Access Compliance Report

Public Rights-of-Way

(Curb Ramps)

Intersection ID: 14978	Main Street: COLONNADE_DR	Cross Street: MONROE_RD	Location: NW
ADA ID: 25CE41BB3B5D	Ramp Type: PerpDiag	Initial Pass/Fail: Fail	Overall Compliance: No
Codes/Mitigation Info/Possible Solution		Field Measurements/Component Compliance

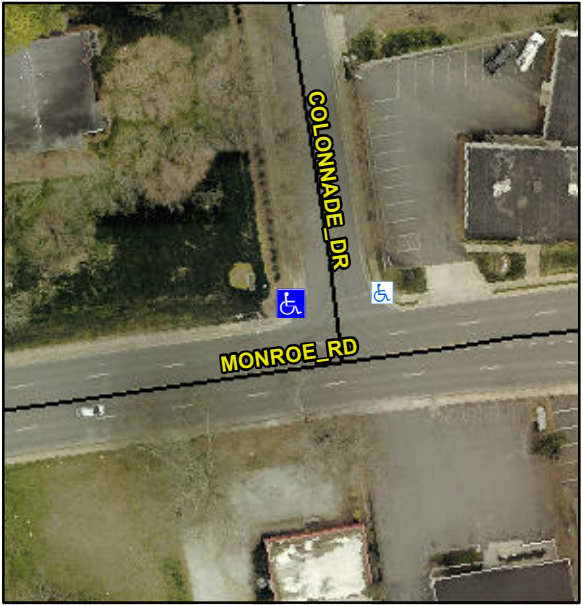
Possible Solutions:	Compliance	Description	Data	Compliance	Description	Data
	Remove & Replace Curb Ramp With Two New Directional Ramps or Equivalent.	N/A	Ramp Length (in)	58.5	No	Ramp Slope (%)	8.9
<p>Surveyor Notes:</p> <p>N/A</p> <p>PROW/ADA:</p> <p>Not Found, R304.5.1, R304.2.2, R304.5.3</p>		No	Ramp Width (in)	39.5	No	Ramp XSlope (%)	5.8
		N/A	Flare Type LT	N/A	N/A	Flare Type RT	N/A
		N/A	Flare Slope LT (%)	N/A	N/A	Flare Slope RT (%)	N/A
		N/A	Flare Traversable LT?	N/A	N/A	Flare Traversable RT?	N/A
		N/A	Landing Length (in)	N/A	N/A	DWS Provided?	N/A
		N/A	Landing Width (in)	N/A	N/A	DWS Contrast?	N/A
		N/A	Landing Slope (%)	N/A	N/A	DWS Length (in)	N/A
		N/A	Landing X Slope (%)	N/A	N/A	DWS Full Width?	N/A
		N/A	Landing Curb? (Y/N)	N/A	N/A	DWS Offset (in)	N/A
		N/A	Shared Landing?	N/A			
		N/A	Gutter Ponding?	N/A	N/A	Gutter Slope (%)	N/A
		N/A	Gutter Lip Ht (in)	N/A	N/A	Gutter X Slope (%)	N/A
		N/A	Painted X Walk1?	No	N/A	Painted X Walk2?	No

X Walk 1 Direction	To S		X Walk 2 Direction	To E
		N/A	X Walk 1 Width (in)	N/A	N/A	X Walk 2 Width (in)	N/A
			X Walk 1 Slope (%)	7.5		X Walk 2 Slope (%)	6.7
			X Walk 1 X Slope (%)	4.8		X Walk 2 X Slope (%)	6.3
		N/A	Ramp inside XWalk1?	N/A	N/A	Ramp inside XWalk2?	N/A
			Road Slope (%)	3.1	N/A	Clear Space?	N/A
			Road X Slope (%)	9.2	N/A	Clear Space to XWalk (in)	N/A
		N/A	Any Obstructions?	N/A	N/A	Storm Grate/Utility Hazard?	N/A
			Obstruction Type			Storm Grate/Utility Type	
					N/A		N/A
					Yes	Surface Condition? (G/P)	Good
